FCC Class II Permissive Change Request Letter

RE: FCC Permissive II Change Request for Company: Bang & Olufsen a/s FCC ID: TTUBS-EXPLORE

We are submitting an application for a class II permissive change to the FCC approval of the Company name: Bang & Olufsen a/s, product description: Bluetooth Speaker (FCC ID: TTUBS-EXPLORE, Original Grant Date: 01/19/2021). The transmitter module itself has not changed. Here are the changes:

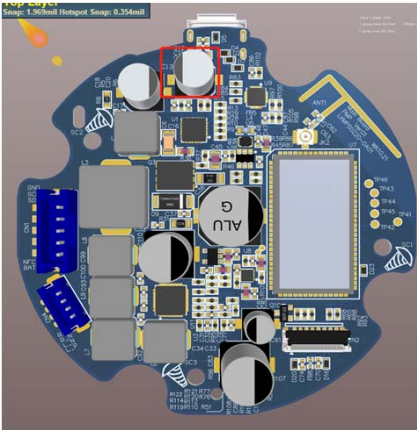
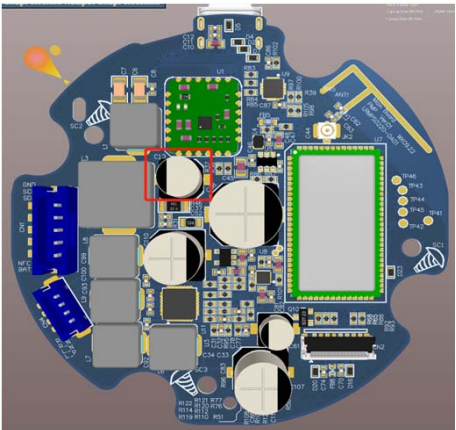
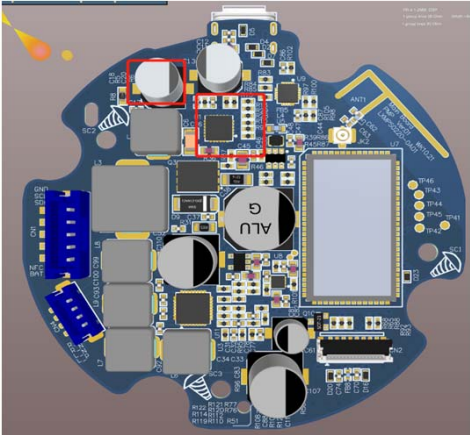
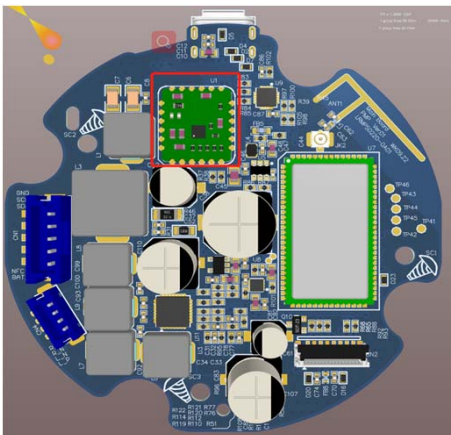
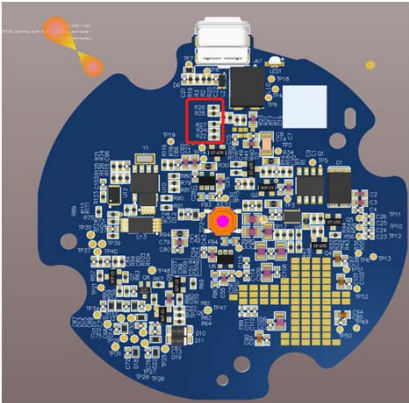
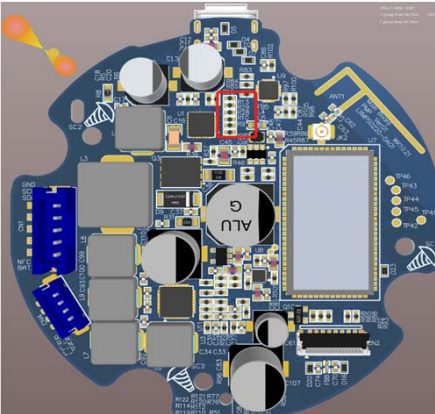
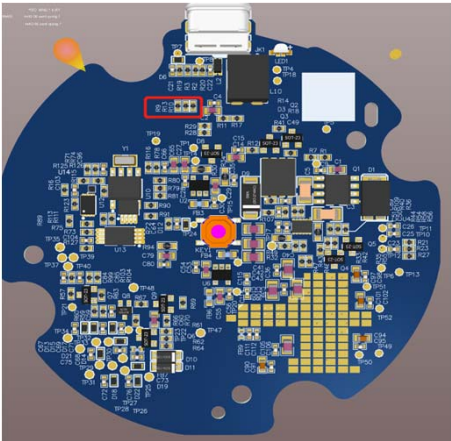
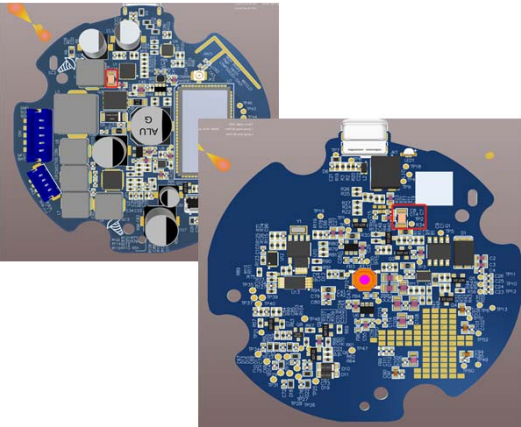
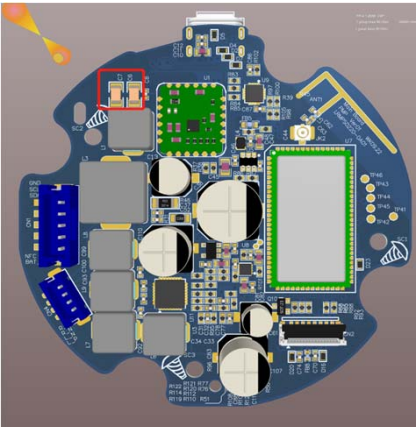
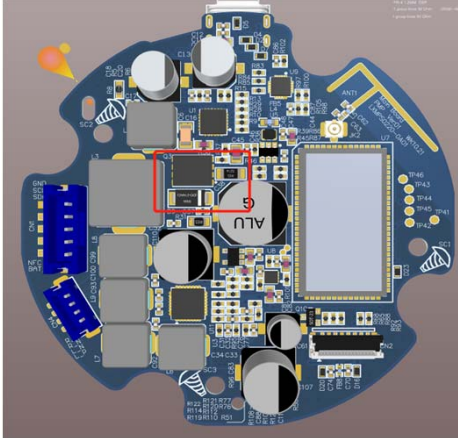
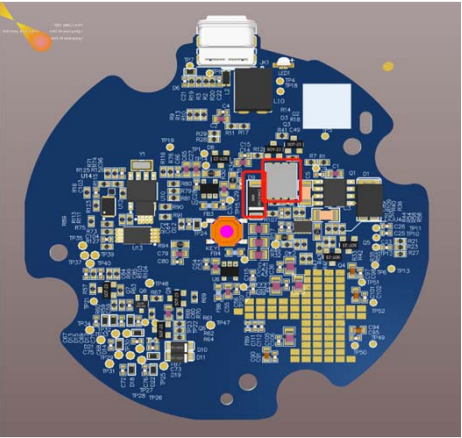
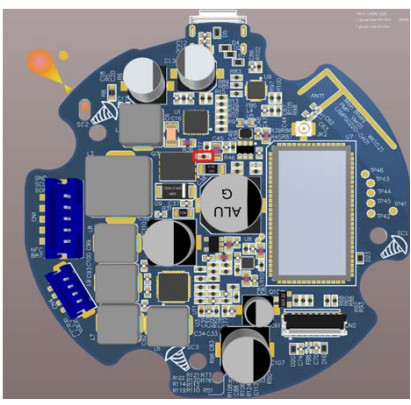
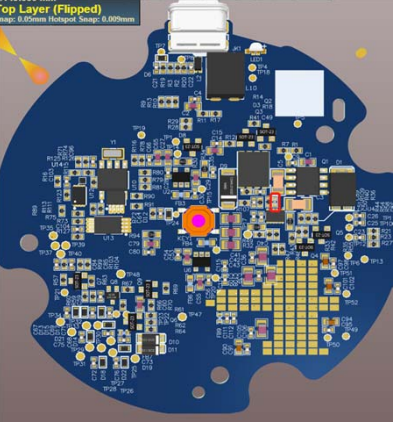
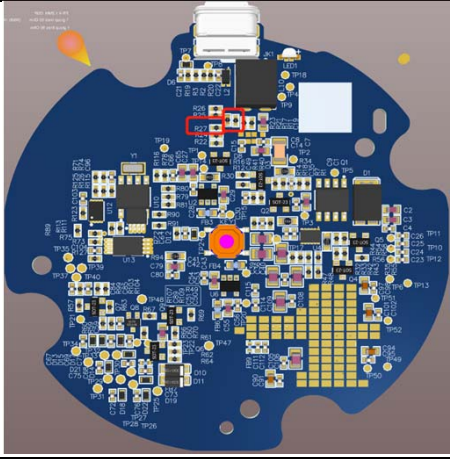
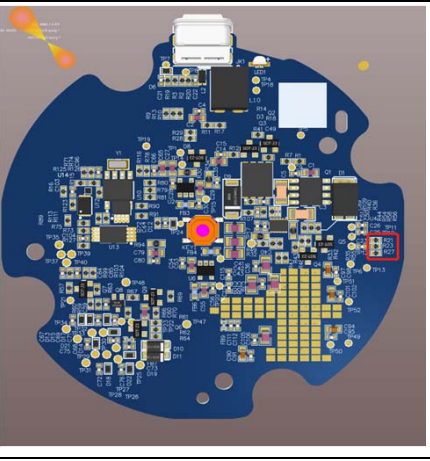
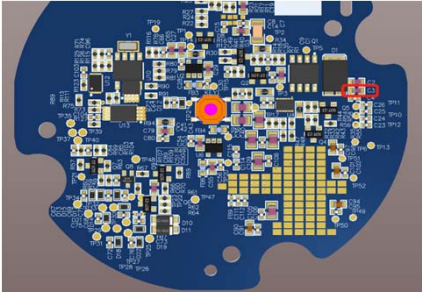
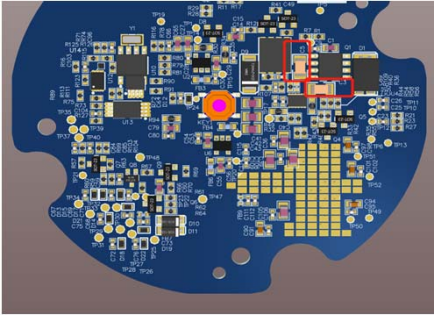
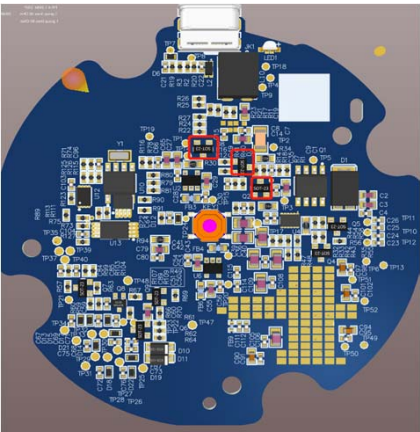
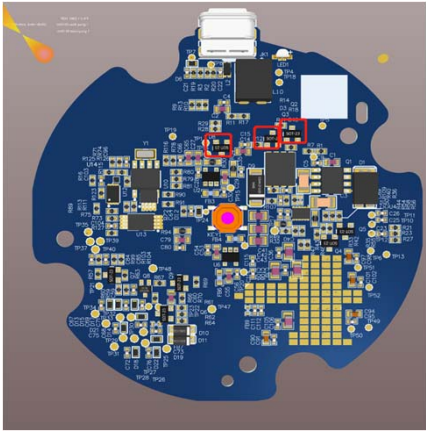
Only the battery charging IC of the motherboard and the PCB layout around the IC are changed, nothing else has been changed, including the wireless module.

Serial number	Before the change	After the change
Battery charging chip: Model change	Model: BQ25883 Location: U1	Model : SGM41528 Location: U1
Main Board PCB: Layout around battery charging chip is slightly changed	N/A	N/A

Changes		
	original	new
C13 Position change		
Delete R4, R6, R15 , C5, C16, C 17, C18, C1 9, C20, L1, R5 , new increase U1		
Delete R22, R24, R 25, R26		
R9, R10, R1 3 Moved to the back

C6, C7 Position change		
Q3, D9 Moved to the back		
R36 Moved to the back		
R21, R23, R 27 Position change

C3 Change packaging new increase C5		
Q2, D3, D8 Position change		
C2, C4 Position change
